SUBJECT: Investigation Radiological Survey and Sampling Results in Response To Request for
Additional Information Concerning Application for Amendment to License STC-133
Dated March 3, 2010, Control No. 143447

**FOLLOW UP INVESTIGATION RADIATION SURVEYS AND
SAMPLING RESULTS**

NEW HAVEN DEPOT

NEW HAVEN, INDIANA

Figure 1: SU 9 Investigation Soil Sample Locations

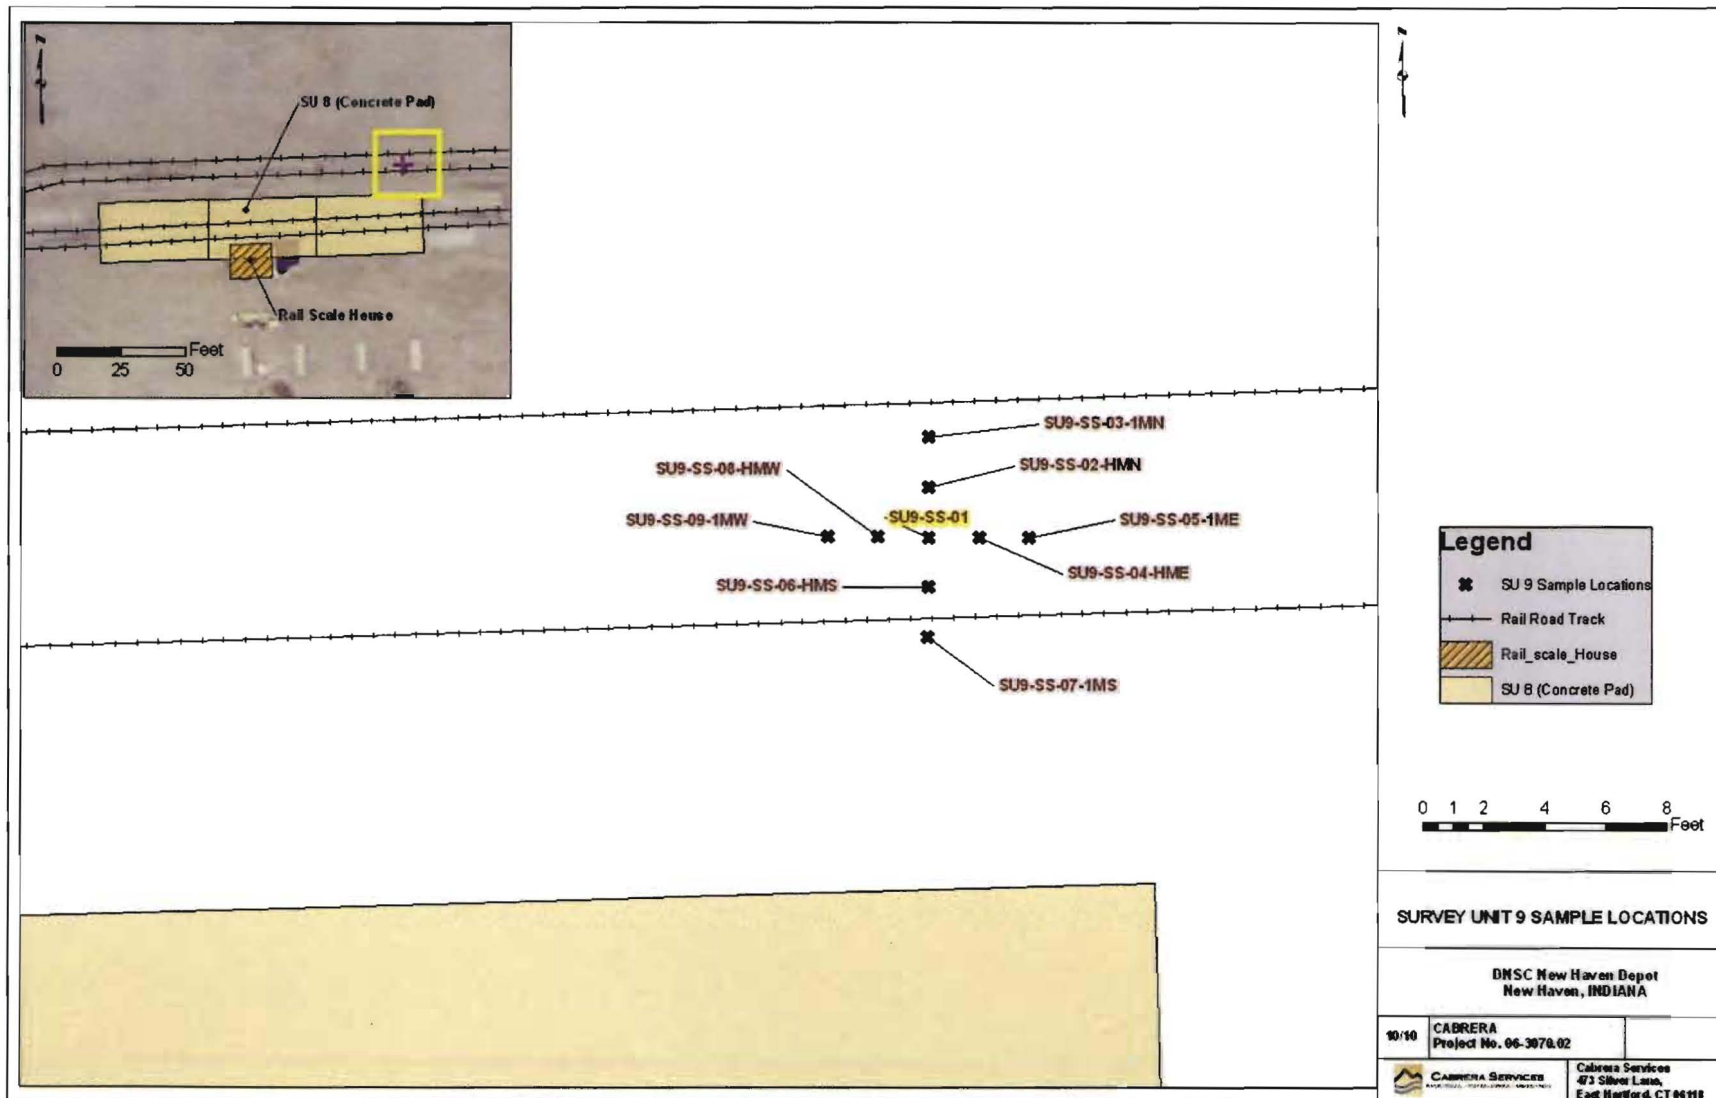
SU 9 is the Class 1 soil area surrounding the rail scale with an area of 241 square meters (m^2). The Confirmatory Survey Report indicates elevated U-238 concentration in soil was discovered in a biased (Judgmental) sample in excess of the area adjusted Derived Concentration Guideline Level ($DCGL_{EMC}$) when evaluated over 4 square meters (m^2). This Judgmental sample was collected on the north side of the rail scale.

A GWS was initially performed to determine if the location of ORISE Judgmental S026 could be identified using the GPS coordinates provided in Table B-2 of the Confirmatory Survey Report. The GWS did not identify an area of elevated activity associated with the area of concern, therefore a series of soil samples were obtained. A single soil sample was obtained at the primary coordinate location; 4 soil samples were obtained at a distance of ½ meter from the primary location (each compass direction); and 4 soil samples were collected at a distance of 1 meter from the primary location (each compass direction). Additionally, a split soil sample was collected with the U.S. Nuclear Regulatory Commission (NRC) which is identified as SU9-NRC-1. The locations of the 9 investigation soil samples collected are shown in Figure 1 and the analytical results are provided in Table 3 which also includes the results for the NRC split soil sample.

As shown in Table 3 none of the analytical results are in excess of the DCGL_w.

Figure 2: SU 210-2-3 Borehole Investigation Location and Surface Activity Measurement Locations

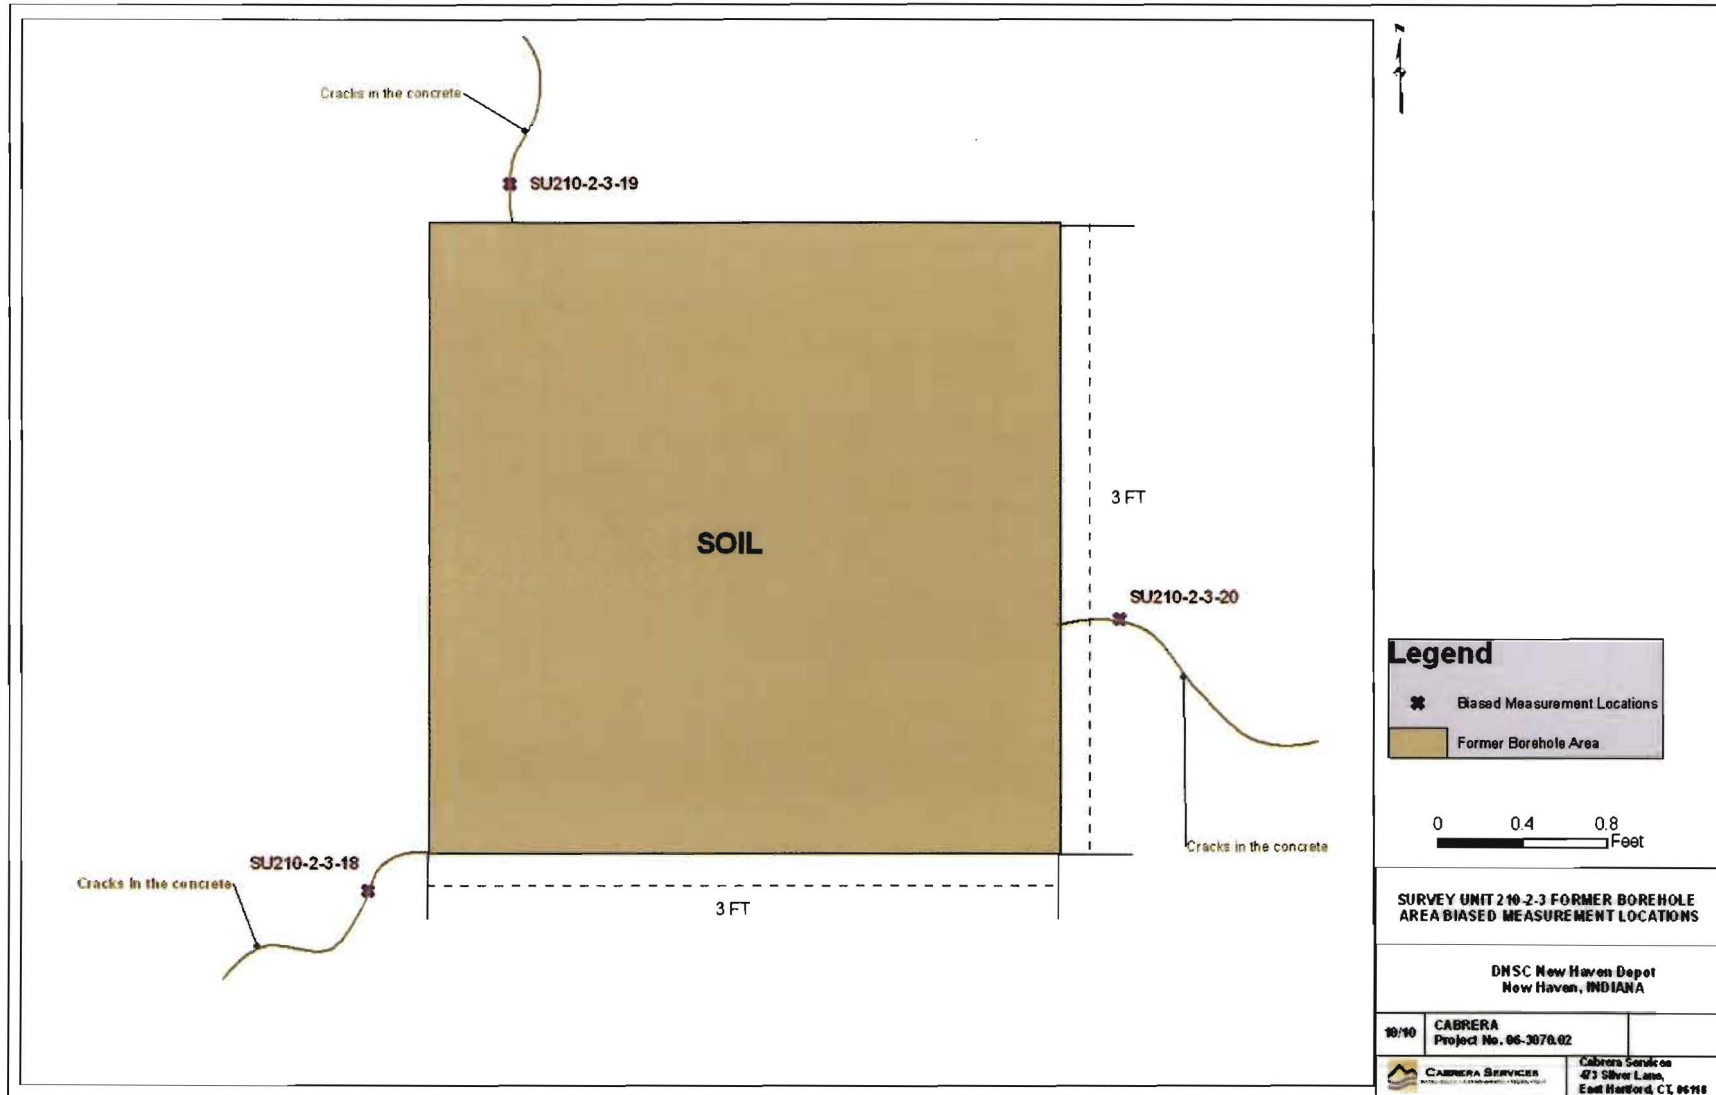
SU 210-2-3 is the Class 1 floor surface north of the location where the concrete slab was removed in Warehouse 210, Section 2 (SU 210-2-6). This Survey Unit has a surface area of $111 m^2$. Although all but two of the six alpha surface activity measurements performed during the Confirmatory Survey were less than the Derived Concentration Guideline Level ($DCGL_W$) of 38 disintegrations per minute per 100 square centimeters ($dpm/100 cm^2$), and the two elevated surface activity results were less than the applied $DCGL_{EMC}$, the Confirmatory Survey Report indicates that elevated beta radioactivity was found at the location of a borehole in this Survey Unit. This is identified as Location 7 on the survey map in the Confirmatory Survey Report which is an additional Judgmental measurement location.

To investigate ORISE Confirmatory Survey Location 7, the concrete floor surface around the borehole location was removed and a sample obtained from the underlying soil. Additionally, surface alpha activity measurements were performed adjacent to the location of removed concrete. The soil analytical results are provided in Table 4 and the surface alpha activity measurement results are provided in Table 5. The locations of the removed concrete and surface activity measurements are provided in Figure 2.

As shown in Table 4, the analytical results for the soil directly below the concrete floor borehole location do not identify RCOC concentrations in excess of the DCGL_w. Surface alpha activity results presented in Table 5 do not identify locations in excess of the surface activity DCGL_w.

Figure 3: SU 210-2-F Surface Activity Measurement Locations

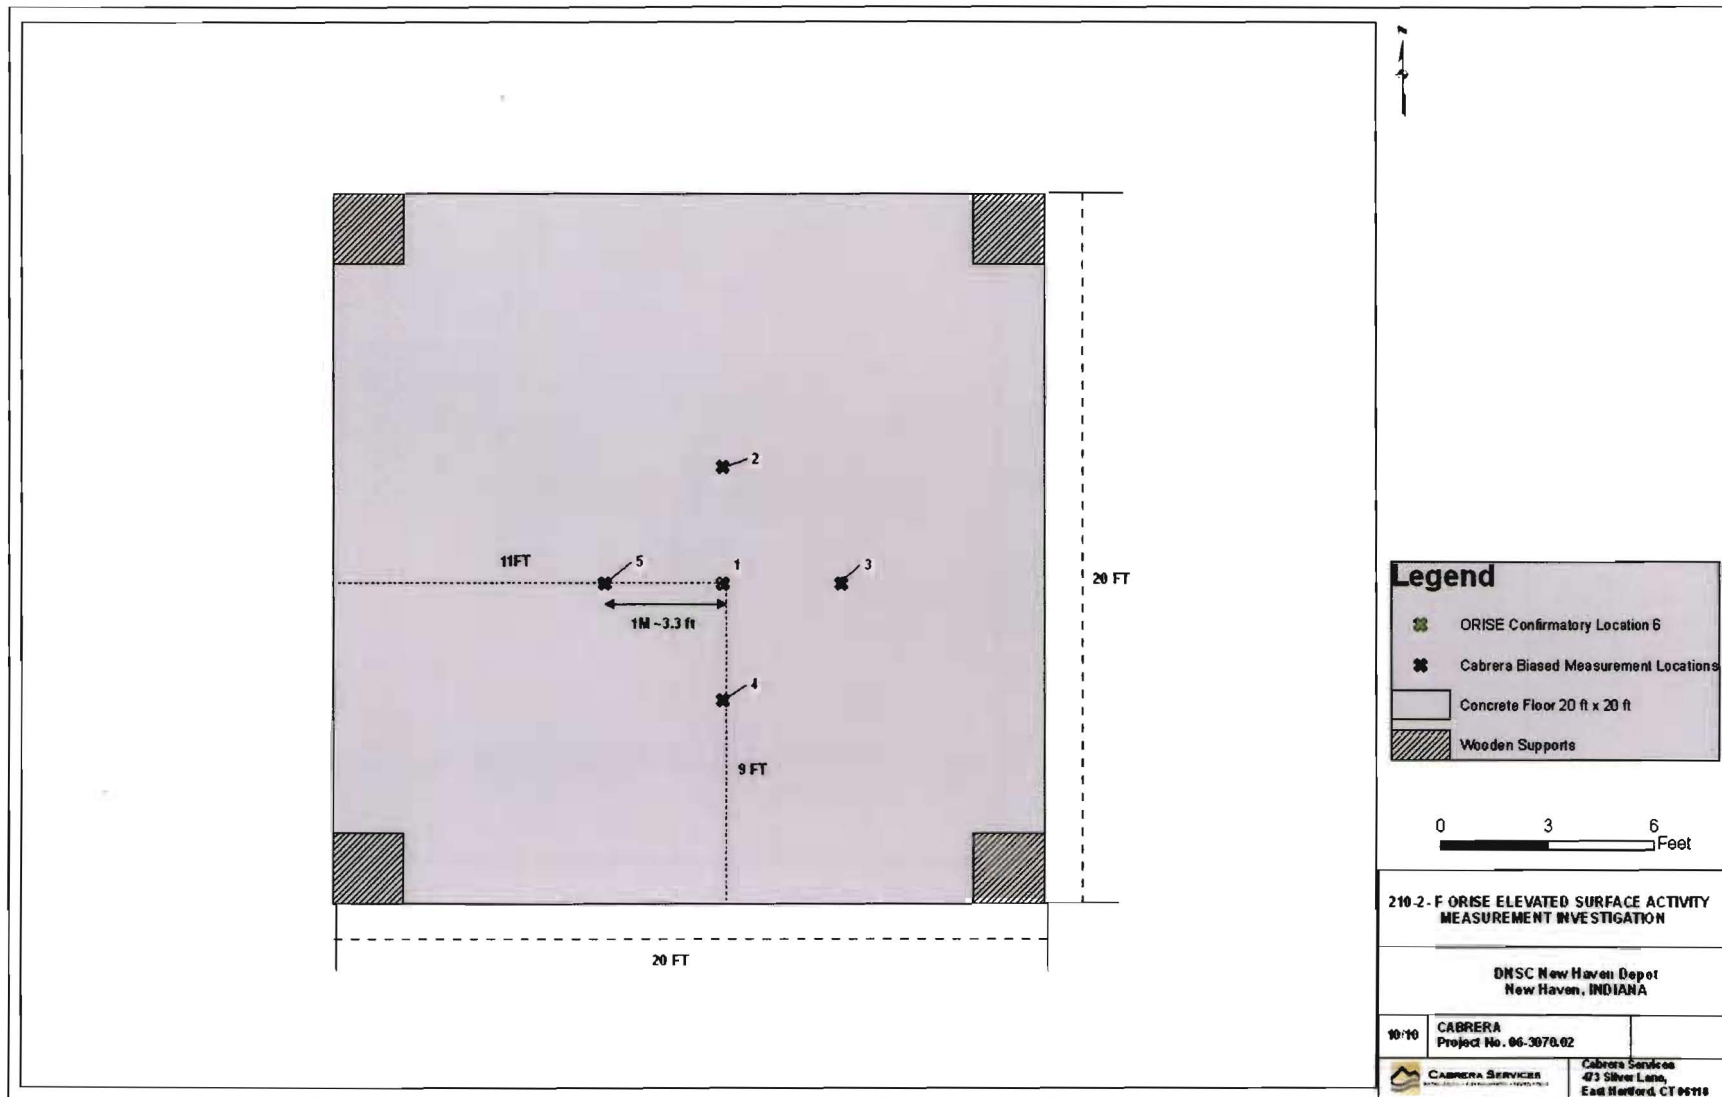
SU 210-2-F in the Confirmatory Survey Report is the remaining Class 3 floor surface in Building 210, Section 2 outside the area of concrete remediation and the bounding Class 1 Survey Units (SU 210-2-1, 210-2-2 and 210-2-3). The Confirmatory Survey Report states the floor area associated with SU 210-2-F was incorrectly designated Class 3 based on one of six surface alpha radioactivity measurement results with a reported activity of 39 dpm/100 cm² when compared to the DCGL_w of 38 dpm/100 cm².

To investigate ORISE Confirmatory Survey Location 6 in SU 210-2-F an alpha surface activity scan was performed covering the area identified by the building coordinates noted in Confirmatory Survey Report Table B-3. The alpha surface activity scan did not identify areas of elevated surface activity. A single direct surface alpha activity measurement was performed at the primary location associated with the building coordinates provided and 4 additional direct surface alpha activity measurements were performed at a distance of 1 meter in each of the 4 compass directions from the primary location. The locations of surface activity measurements are provided in Figure 3 and the survey results are provided in Table 6.

Surface alpha activity results presented in Table 6 do not identify locations in excess of the surface activity DCGL_w.

Figure 4: SU 145-F-1, 145-F-2 and 145-F-3 Systematic Surface Activity Measurement Locations

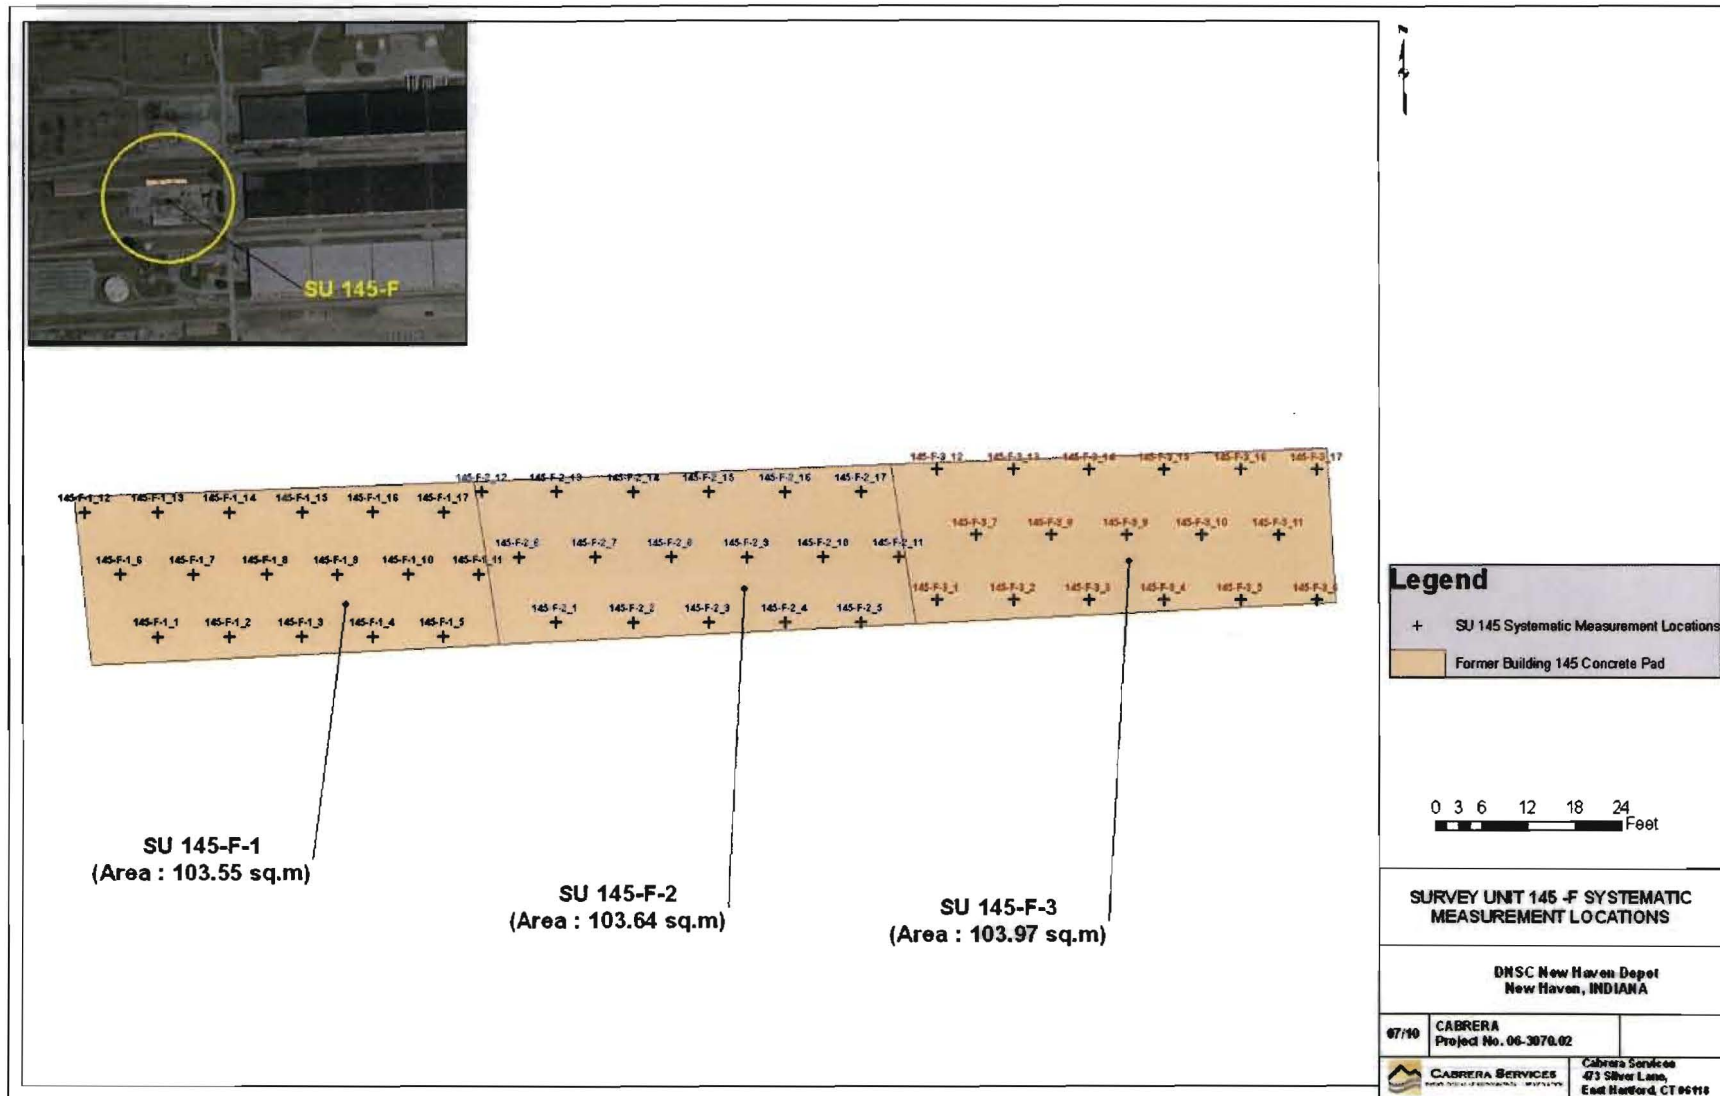
SU 145-F is the Class 3 outdoor concrete slab, where a structure once stood, with an area of 323 m². The Confirmatory Survey Report indicates that four of the six surface activity measurement results were greater than the DCGL_w of 100 dpm/100 cm², with the conclusion that this Survey Unit was incorrectly designated as Class 3.

To investigate the potential elevated surface activity locations identified in the Confirmatory Survey Report, SU 145-F was divided into 3 Survey Units, each approximately 108 m² in size. These Survey Units are identified as SU 145-F-1, 145-F-2 and 145-F-3. A surface alpha scan was performed over all accessible surfaces in each Survey Unit. A total of 17 systematic direct alpha surface activity measurements were performed in each Survey Unit and additional biased surface activity measurements performed as indicated by the alpha surface activity scan. The locations of the systematic direct surface alpha activity measurements are provided in Figure 4 and the results provided in Tables 7, 8 and 9.

Surface alpha activity results presented in Tables 7, 8, 9 and 10 do not identify locations in excess of the surface activity DCGL_w.

Figure 6: SU 8-1, 8-2 and 8-3 Systematic Surface Activity Measurement Locations

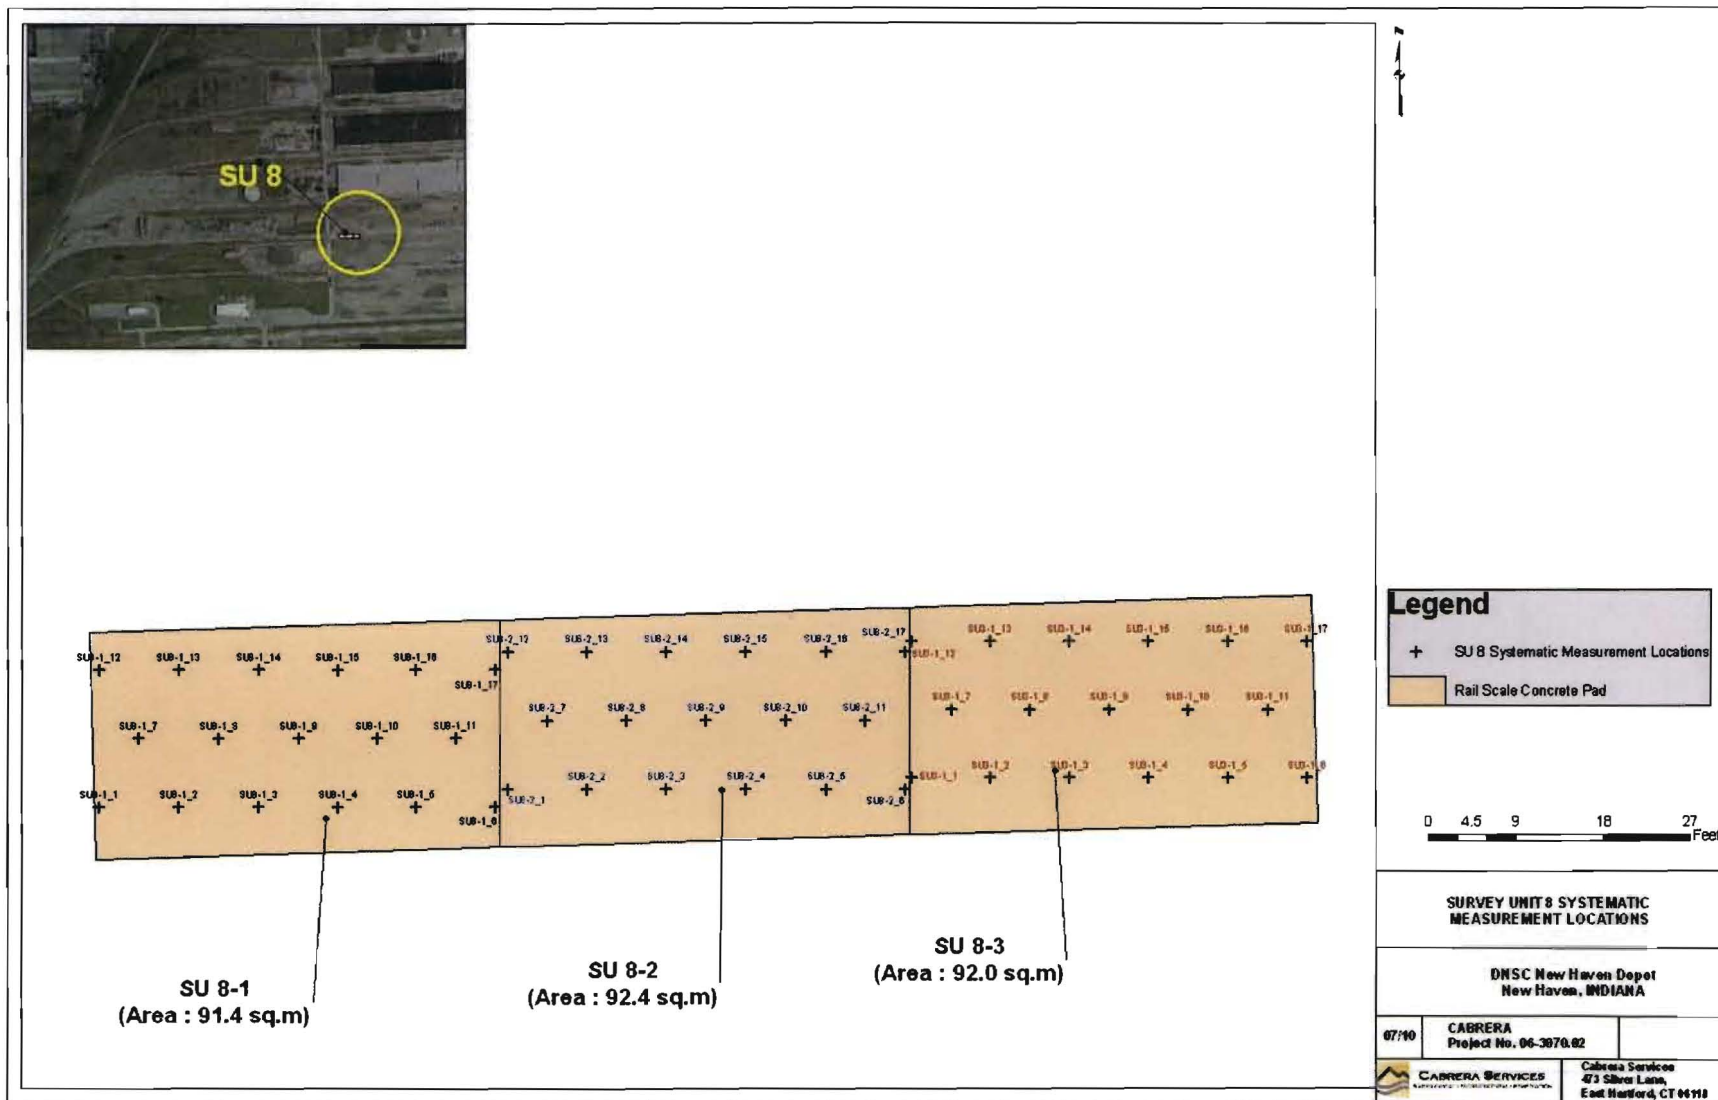
SU 8 is the concrete rail scale, a Class 2 Survey Unit, with an area of 276 m². Although five of the six surface activity measurements obtained during the Confirmatory Survey were below the DCGL_w of 100 dpm/100 cm², the Report states that elevated alpha surface activity in excess of the DCGL_w was found on a crack in the concrete, resulting in incorrect designation of the Survey Unit as Class 2.

To investigate the potential elevated surface activity location identified in the Confirmatory Survey Report, SU 8 was divided into 3 Survey Units, each approximately 92 m² in size. These Survey Units are identified as SU 8-1, 8-2 and 8-3. A surface alpha scan was performed over all accessible surfaces in each Survey Unit. A total of 17 systematic direct alpha surface activity measurements were performed in each Survey Unit and additional biased surface activity measurements performed as indicated by the alpha surface activity scan. The locations of the systematic direct surface alpha activity measurements are provided in Figure 6 and the results provided in Tables 11, 12 and 13.

Surface alpha activity results presented in Tables 11, 12, 13 and 14 do not identify locations in excess of the surface activity DCGL_w.
